Pushing Performance Since 1945	HARTING Product Termination Notification	PTN
--	---	------------

Business Unit:	Electronics	PTN/22/016/PM+MD
Product range:	Board connectors / DIN Signal + har-bus 64	Date: 2022-06-08
Author:	Ansgar Thomas	
Title:	PTN DIN Signal type B female IDC - External.docx

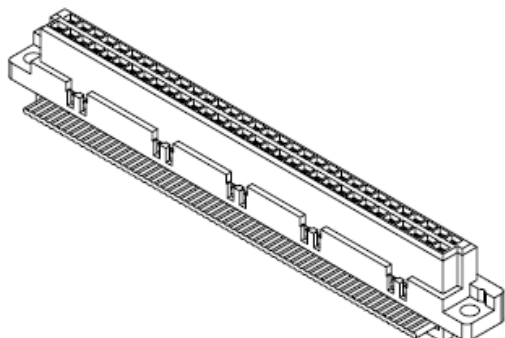
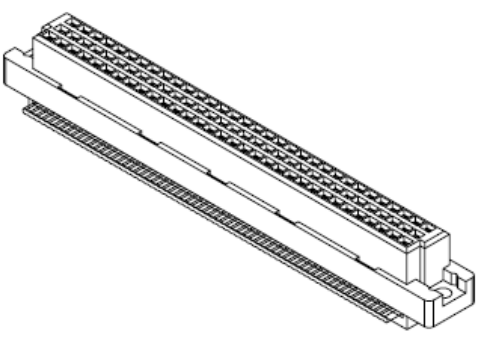
1. Concerned part number (see also attachment):
09 02 264 6828 and 09 02 264 7828 .
2. Reason for termination:
<p>To continue the production there are significant investments needed. Due to low demand this is not reasonable. Therefore we have to phase out these two products.</p>

3. Possible replacement products
<p>As replacement product we can offer 09 03 264 6828 and 09 03 264 7828.</p> <p>The replacement product is type C with 3 rows. Contacts are loaded in rows a & c. The phase out products are type B with 2 rows. Contacts are loaded in rows a & b. They are not mating compatible. In case of replacement the mating male connector have to be changed as well from type B to type C or from type Q to type R.</p> <div style="display: flex; justify-content: space-around; align-items: flex-end; margin-top: 20px;"> <div style="text-align: center;">  <p style="color: blue; font-style: italic;">3D View of old product</p> </div> <div style="text-align: center;">  <p style="color: blue; font-style: italic;">3D View of replacement product</p> </div> </div>
